From: Mary Wall <mary@pe-services.biz>
Sent: Tuesday, January 20, 2026 9:15 AM
To: Clerks Comment; City Clerk
Cc: Nick Napoli
Subject: RE: 24-51 Meridian Luxe (H-2025-0035)- Request for Reconsideration of Minimum Tree Size for Residential/Commercial Landscape Buffer

Please accept this email as our formal Request for Reconsideration of the requirement for 6-inch caliper deciduous trees to be placed in the landscape buffer adjacent to the existing residential zone.

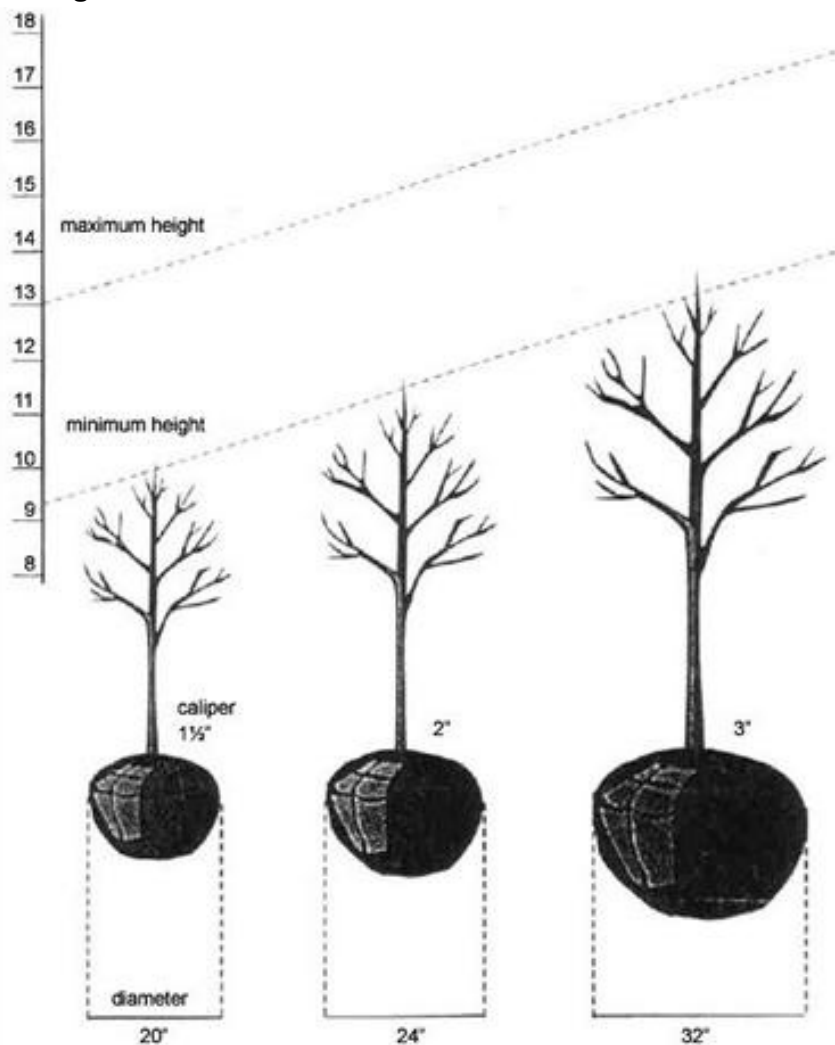
Due to the unavailability of the 6-caliper inch deciduous trees at the local nurseries, we are requesting reconsideration of this requirement. We propose installing trees that are readily available at the local

nurseries but are older, larger and fuller than the minimum size normally required by Code (2-caliper inch). The figure below demonstrates how much taller and fuller a 3-caliper inch tree is versus a 2-caliper inch tree. The 3-caliper inch tree is typically 3 to 4 feet taller than the 2-caliper inch tree.
